## ***Interactive comment on “Applying a simple water-energy balance framework to predict the climate sensitivity of streamflow over the continental United States” by M. Renner and C. Bernhofer***

### **Author reply to referee II**

**Fig. 1.** Observed change direction in UW space compared for different potential evapotranspiration inputs.

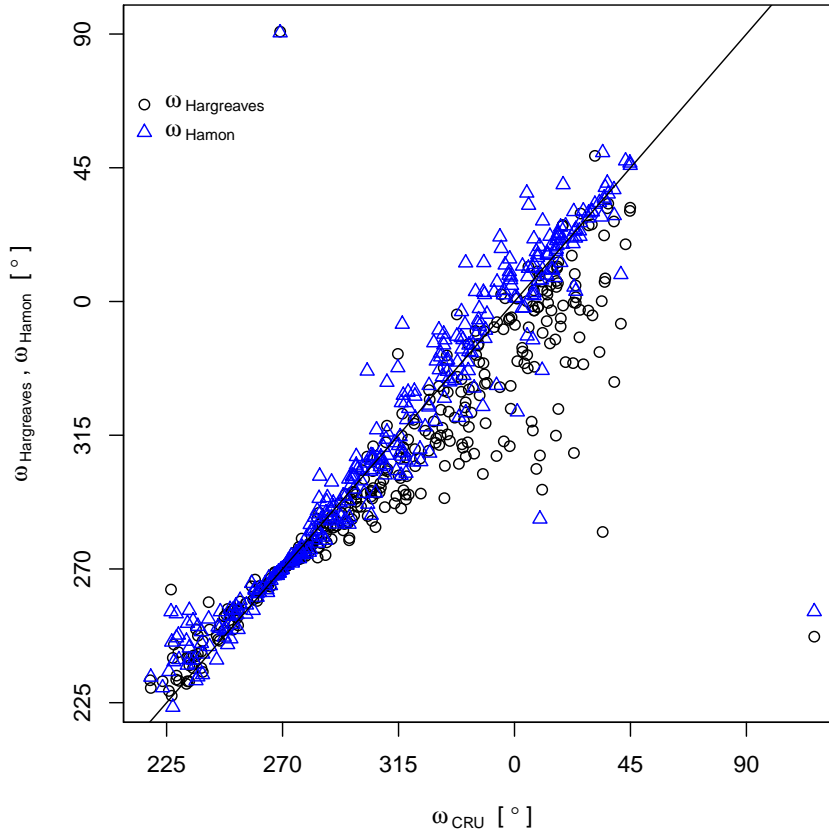
Another type of error which is rather systematic comes from the definitions of potential evapotranspiration. Especially the use of the temperature range based Hargreaves equation was criticised by the referee. We tried to get hold of this type of error by using the temperature based Hamon equation and an external product which includes cloudiness information (CRU TS 3.1). The comparison to the climatology estimate delivered with the MOPEX dataset as well as the correlation to the observed changes actually reinstates the problems with the Hargreaves estimates (more significant changes in  $E_p$  than with the other two methods).

The effect of the different  $E_p$  methods on the observed change direction  $\omega_{obs}$  can be seen in Figure 1 of this reply. For basins with  $\omega_{obs}$  close to  $270^\circ$  we find very small differences, which is due to large decreases in relative excess energy  $U$ . The differences increase towards larger  $\omega_{obs}$ . This is because also the aridity index decreases (cf. Fig. 8 of the revision) and the limiting role of  $E_p$  gets more important and thus also the uncertainties in  $E_p$ . Further, under the dominant impact of potential basin changes  $\omega_{obs} \approx 225, 45^\circ$  the effect of uncertainties in  $E_p$  on  $\omega_{obs}$  can be substantial. This is because the errors in the input are directly translated as basin change impacts.

**Fig. 2.** Scatterplot of predicted streamflow changes of CCUW vs. Schreiber.

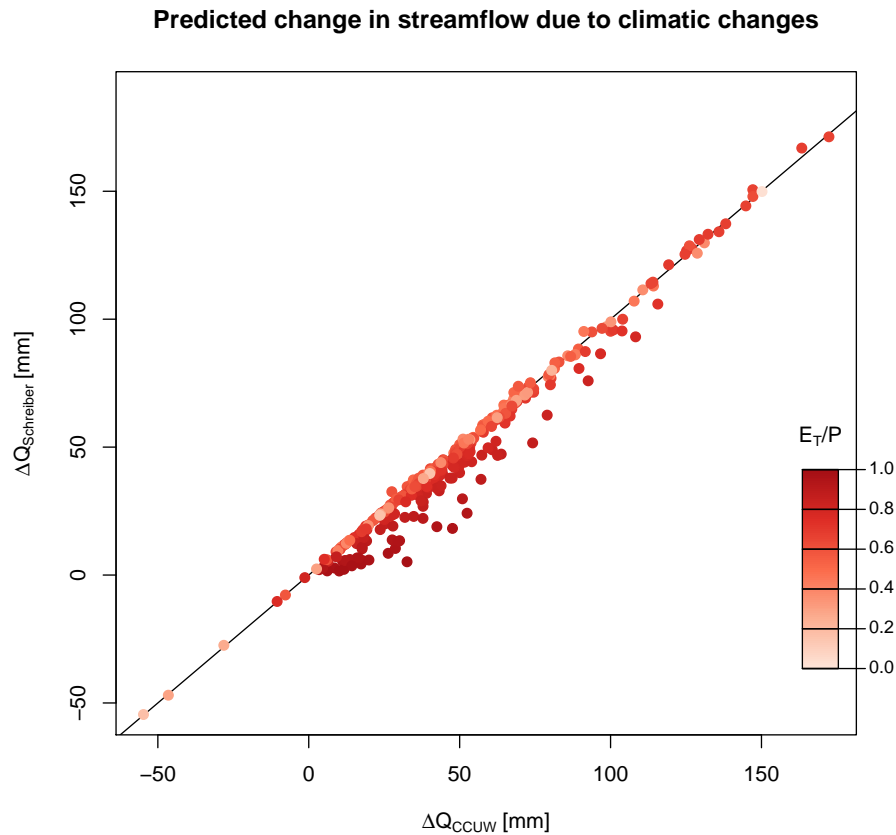
The referee wished that results for the Schreiber equation should be shown in the results. Instead, Referee I suggested to remove all the non-parametric Budyko curves from the analysis. For reasons of clarity, we followed the suggestion of Referee I and removed the other Budyko functions from the manuscript.

Here we attach two figures which show that there are no strong deviations in the results when using the Schreiber equation for streamflow sensitivity. Figure 2 shows the difference in streamflow change predictions of the Schreiber method as function of the CCUW. For basins with low  $E_T/P$  the predictions are quite similar, while for higher  $E_T/P$  and moderate streamflow increases the Schreiber equation predicts smaller changes than CCUW.
